ADDENDUM #3

GADSDEN CITY HALL

Gadsden, AL WBA #23-083.00

DATE: 13 December 2024

NORTH 2 PRESSURE PIPING - 1ST FLOOR PLAN - CITY COUNCIL - ENLARGED
SCALE: 1/4" = 1'-0" REF: 1/P-303

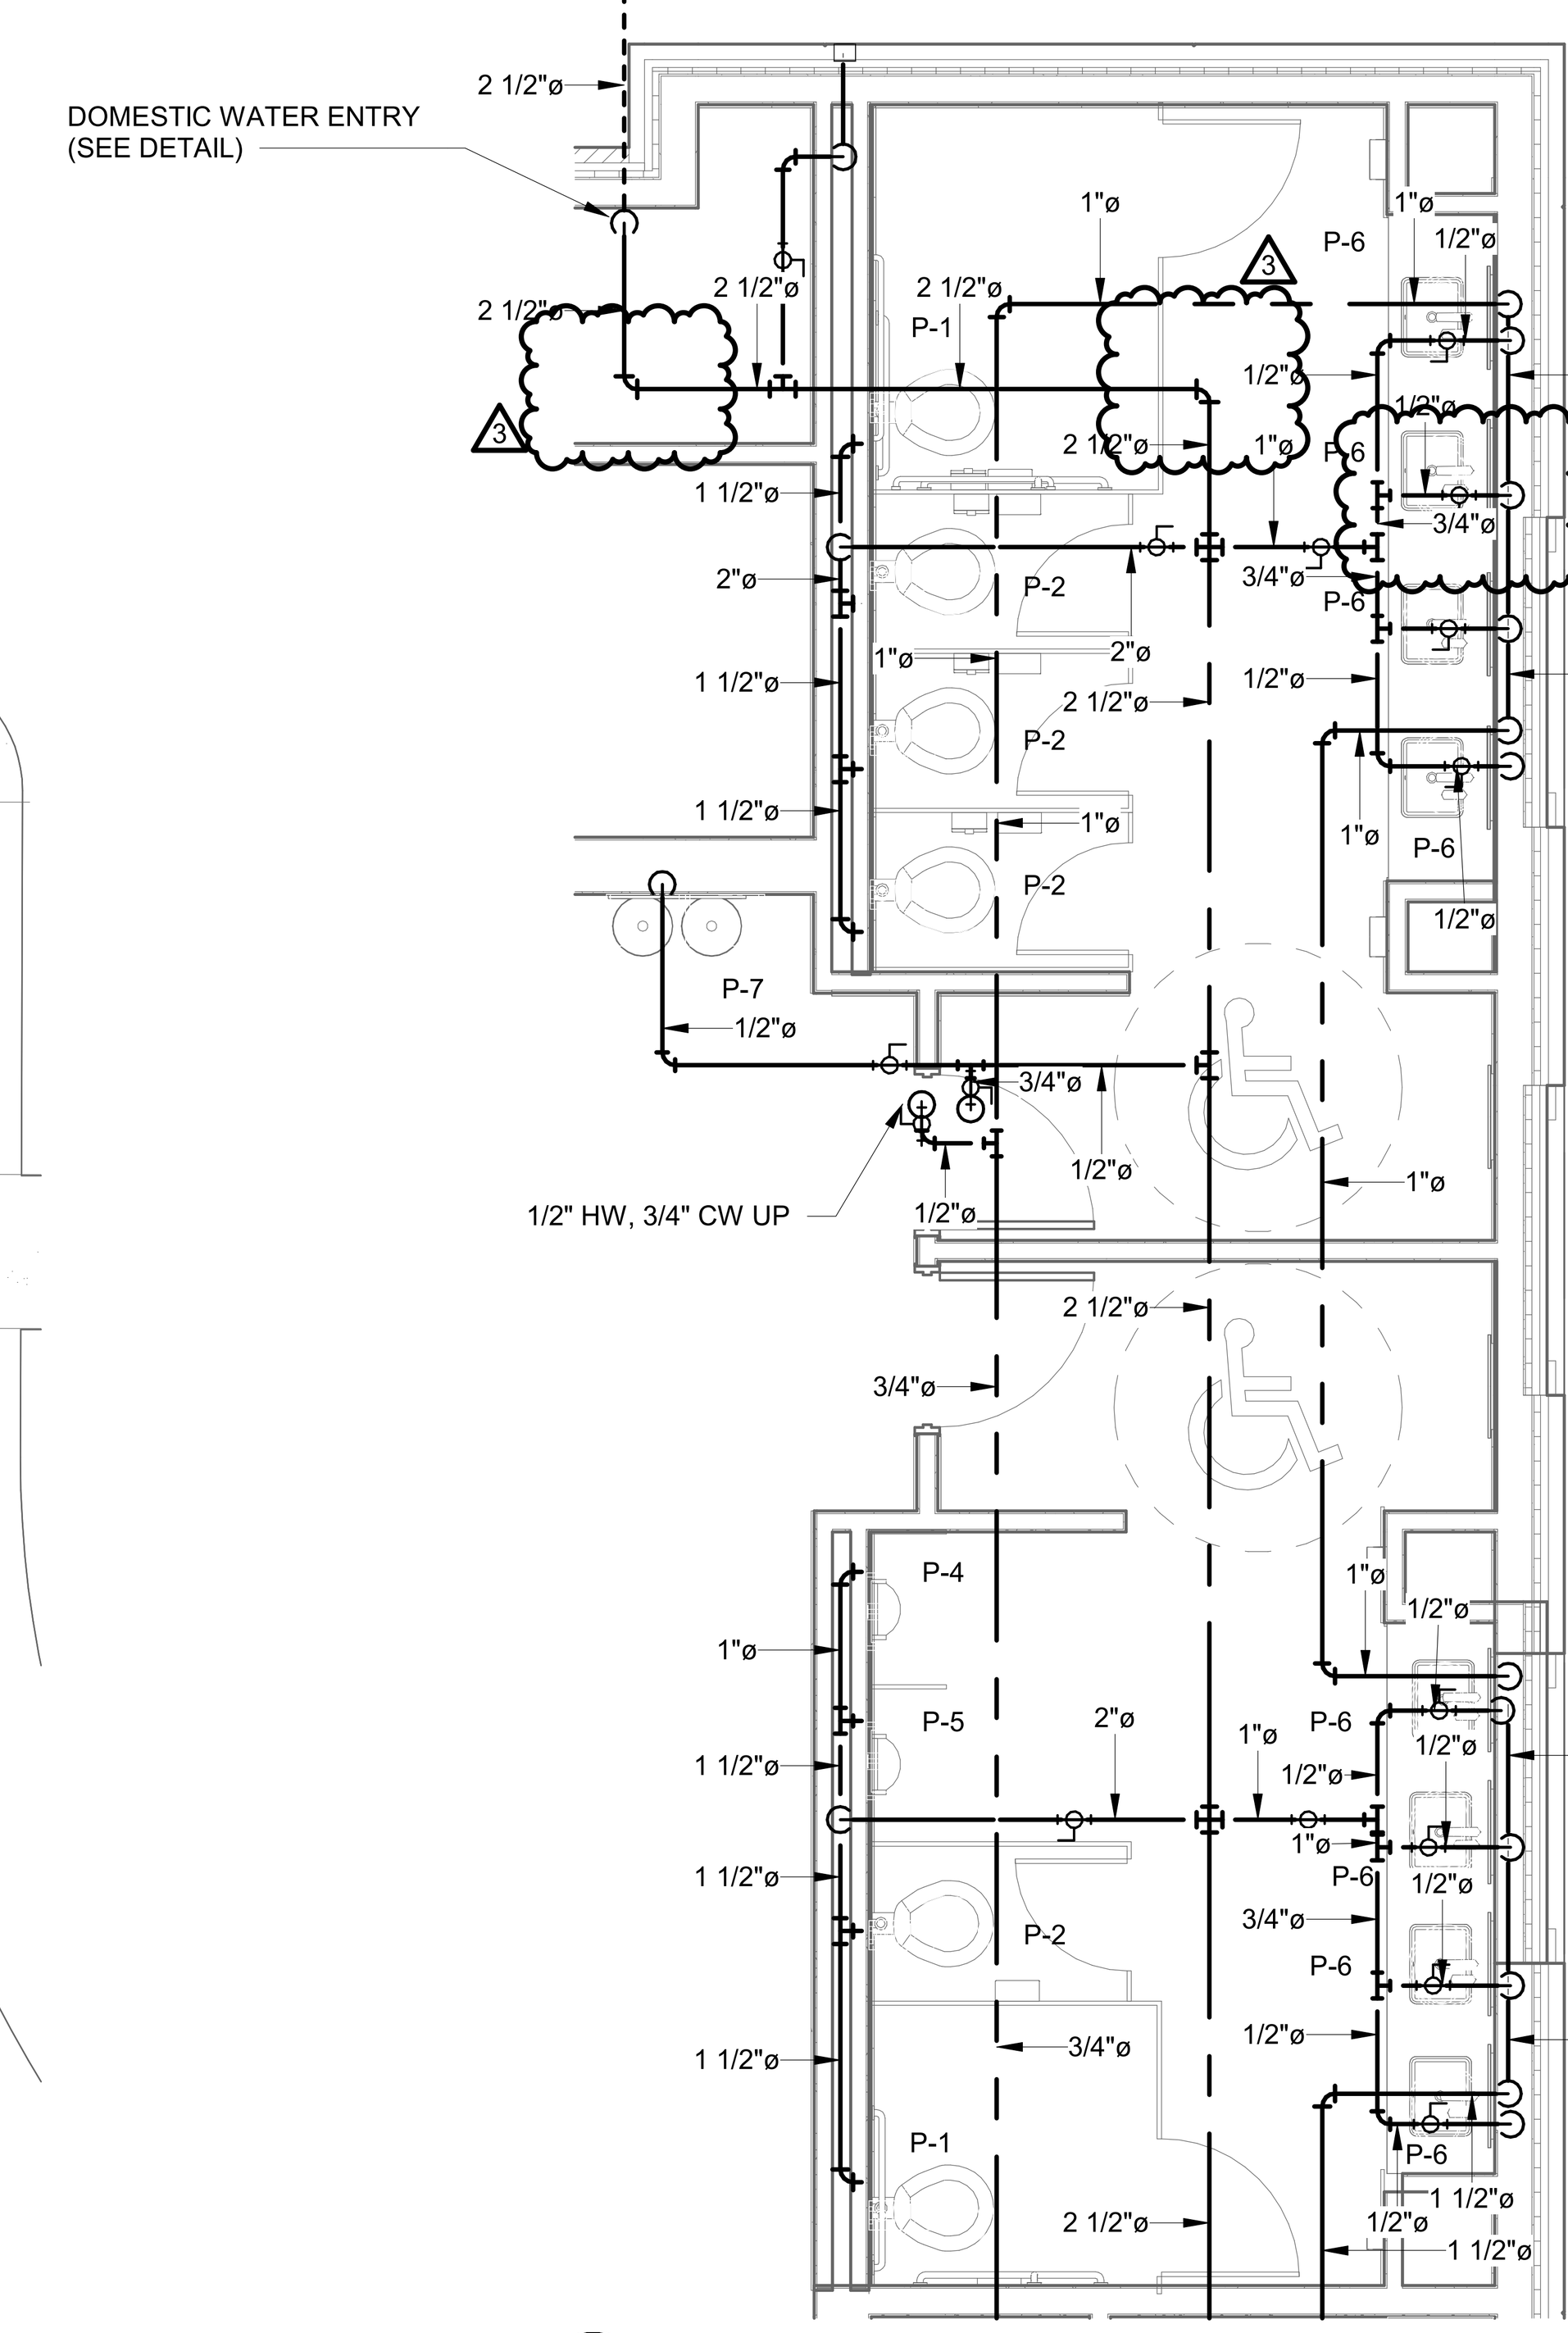
53. **Sheet P-303 – PRESSURE PIPING – 1st FLOOR PLAN – CITY COUNCIL:**
    a. Drawing 2/P-303 – PRESSURE PIPING – 1st FLOOR PLAN – CITY COUNCIL – ENLARGED: Tagged wall hydrants associated pipe on riser. Moved tags for readability. Removed excess ball valve.
    b. Updated Riser Diagram to reflect revisions to drawing 2/P-303 – PRESSURE PIPING – 1st FLOOR PLAN – CITY COUNCIL – ENLARGED.
    c. See attachments.

1 LIGHTING - 1ST FLOOR PLAN - CITY COUNCIL
SCALE: 1/8" = 1'-0"

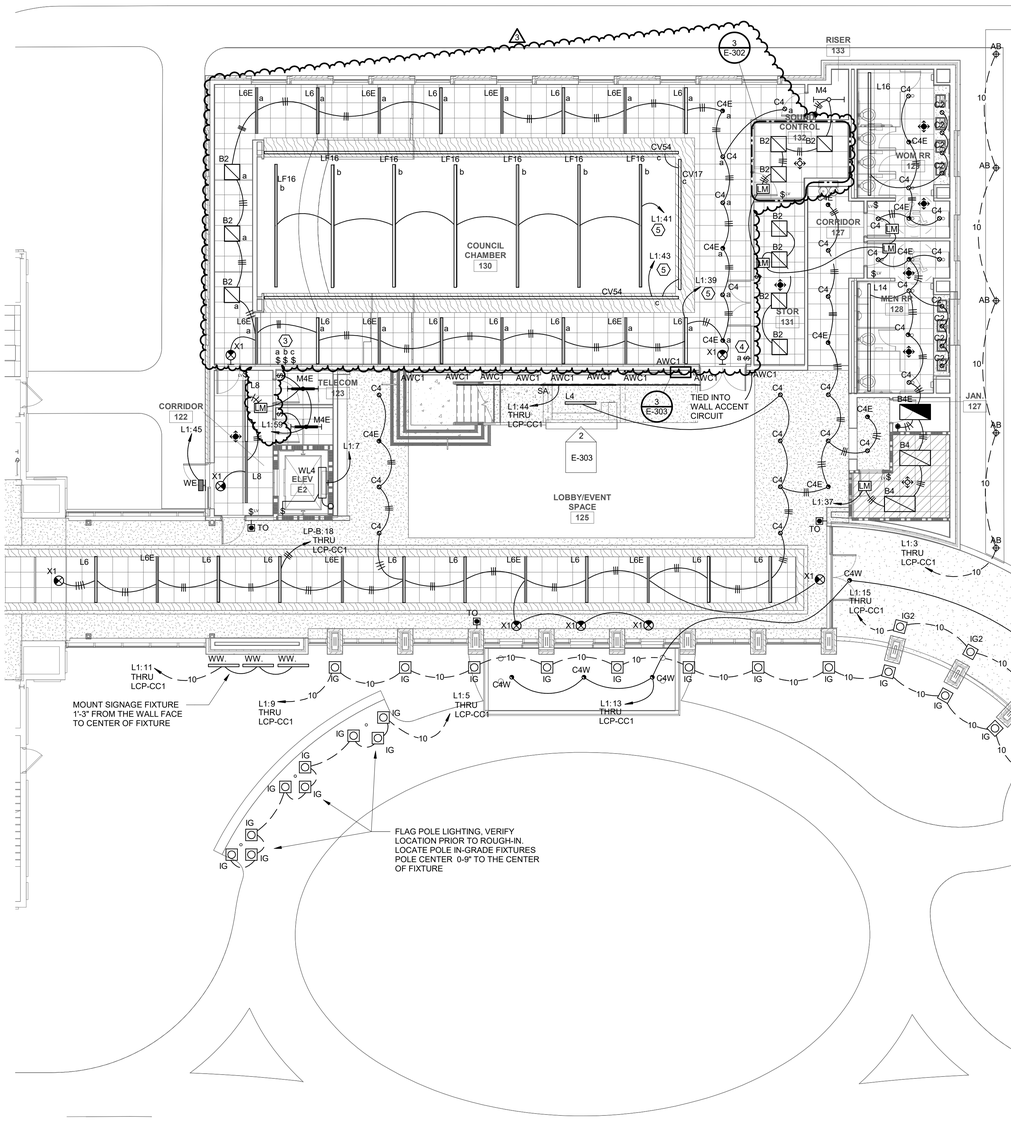
55. **Sheet E-302 – ELECTRICAL LIGHTING 1st FLOOR PLAN – CITY COUNCIL:**
    a. Revised lighting controls in Council Chambers.
    b. See attachments.

1 POWER - 1ST FLOOR PLAN PLAN - CITY HALL
SCALE: 1/8" = 1'-0"

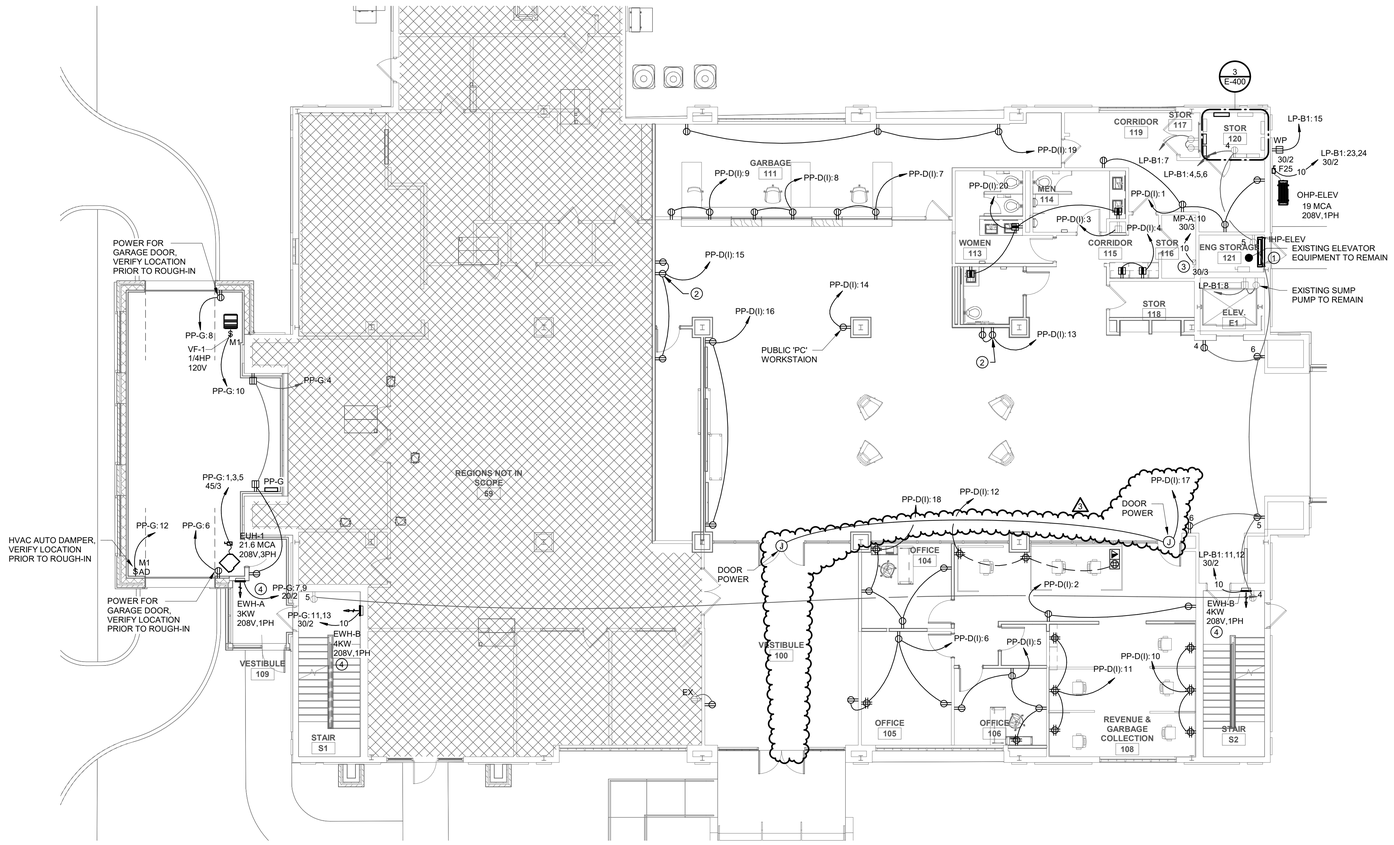
56. **Sheet E-400 – ELECTRICAL 1st & 2nd FLOOR PLANS – CITY HALL:**
    a. Drawing 1/E-400 – POWER – 1st FLOOR PLAN – CITY HALL: Updated automatic door locations.
    b. See attachments.

1 TECHNOLOGY - COMMUNICATION - 1ST FLOOR PLAN PLAN - CITY HALL

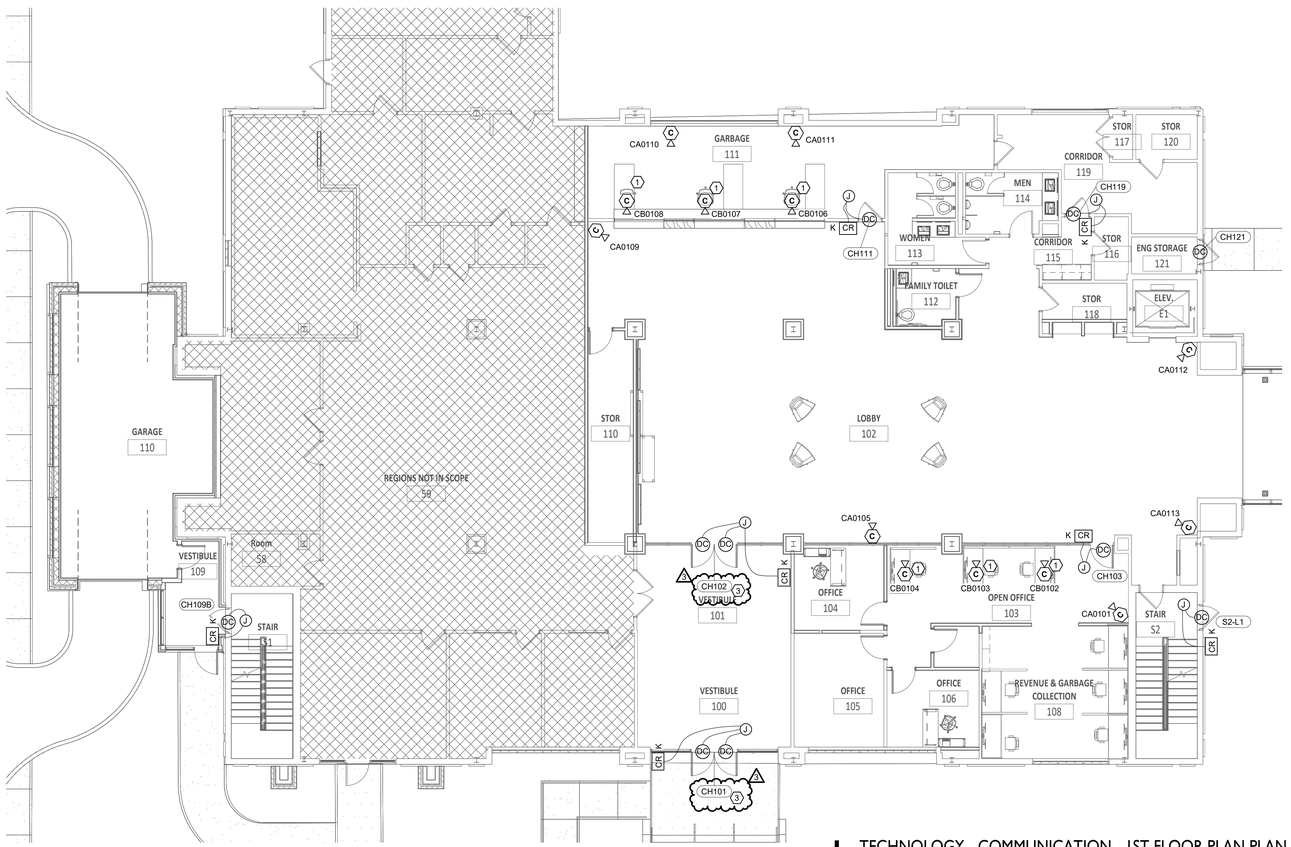
60. **Sheet T-400 – TECHNOLOGY – COMM – 1st & 2nd FLOOR PLAN – CITY HALL:**
    a. Drawing 1/T-400 – TECHNOLOGY – COMMUNICATION – 1st FLOOR PLAN – CITY HALL: Tagged Key Note 3 and Key Note 4.
    b. Added Keyed Note 3 and Key Note 4.
    c. See attachments.

TECHNOLOGY - COMMUNICATION - 1ST FLOOR PLAN - CITY COUNCIL

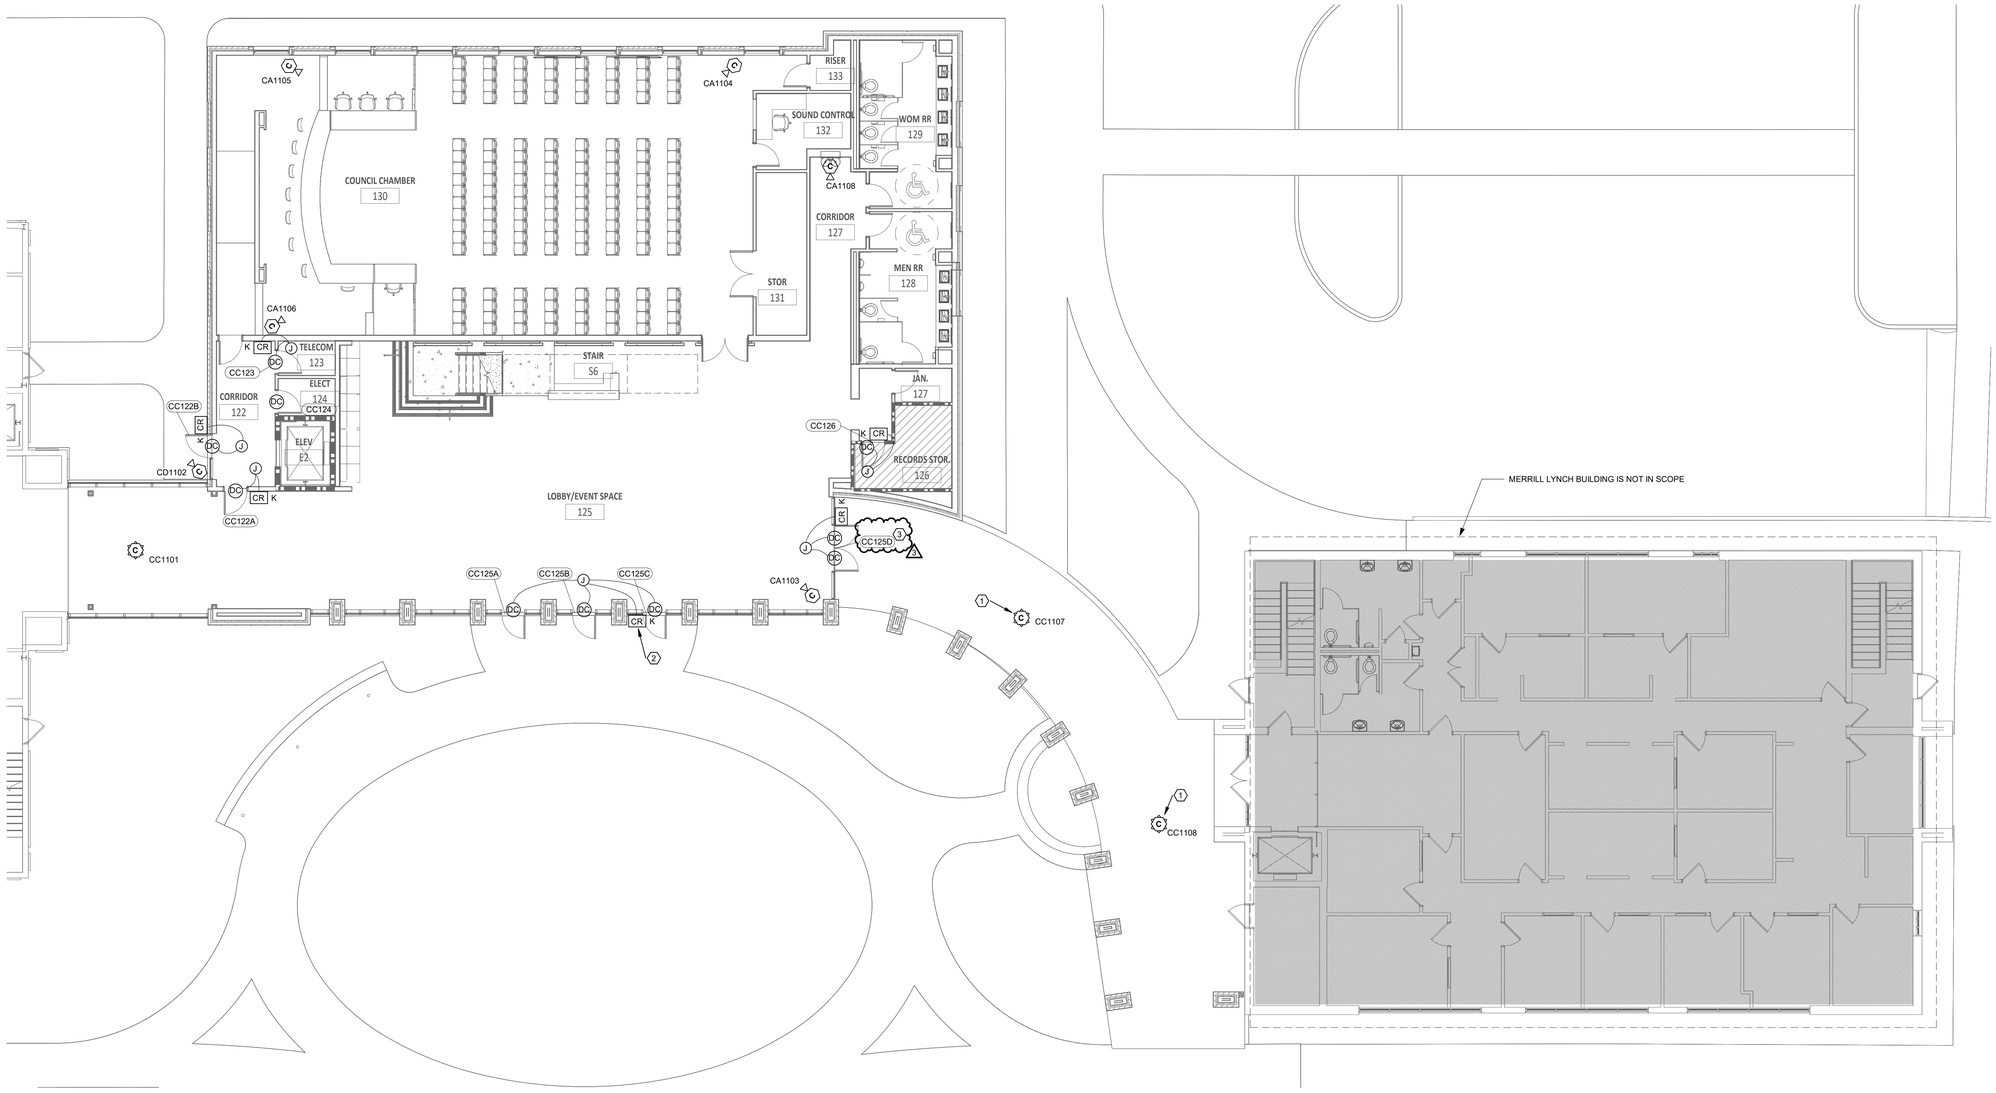
61. **Sheet T-402 – TECHNOLOGY – COMM – 1st FLOOR PLAN – CITY COUNCIL:**
    a. Drawing 1/TECHNOLOGY – COMMUNICATION – 1st FLOOR PLAN – CITY COUNCIL: Tagged Key Note 2 and Key Note 3.
    b. Added Keyed Note 2 and Keyed Note 3.
    c. See attachments.
